NEW
JMF102
1220M DUCT
56 WITH 6X
JMF 102 ON
ROUTE
10M DUCT 54 TO
EXISTING JBF104

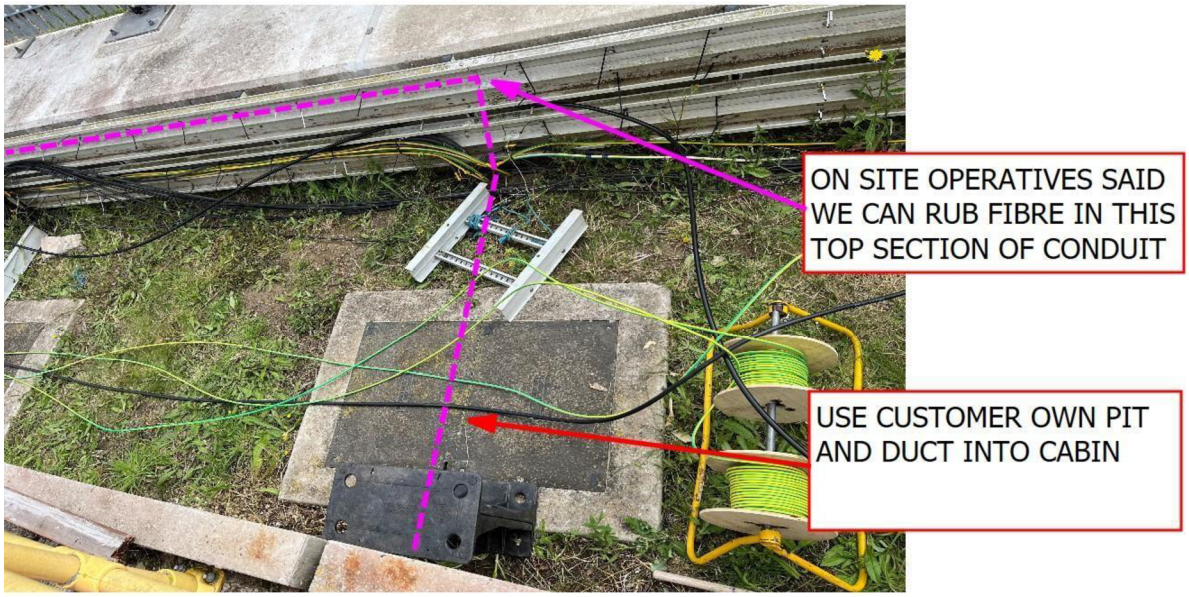
1220M DUCT 56 WITH 6X JMF 102 ON ROUTE
STEEL DUCT REQUIRED BETWEEN THERE BOXES AS NEEDS TO GO OVER DITCH

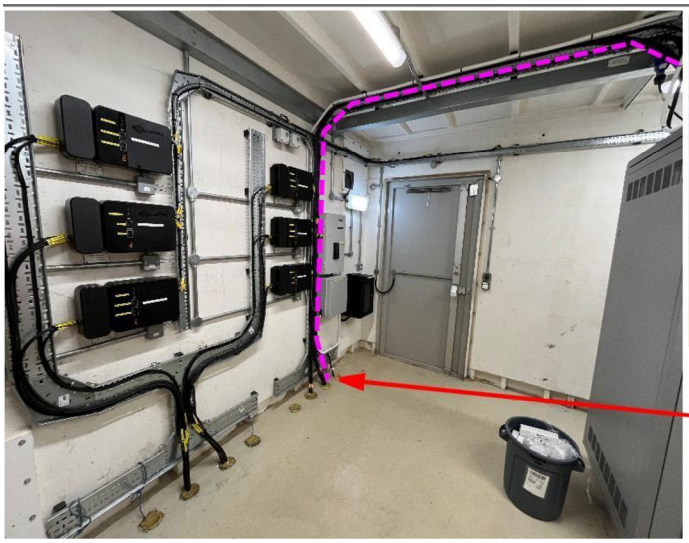
DUCT TURN UP
HERE

ON SITE OPERATIVES SAID
WE CAN RUB FIBRE IN THIS
TOP SECTION OF CONDUIT

ON SITE OPERATIVES SAID
WE CAN RUB FIBRE IN THIS
TOP SECTION OF CONDUIT
USE CUSTOMER OWN PIT
AND DUCT INTO CABIN
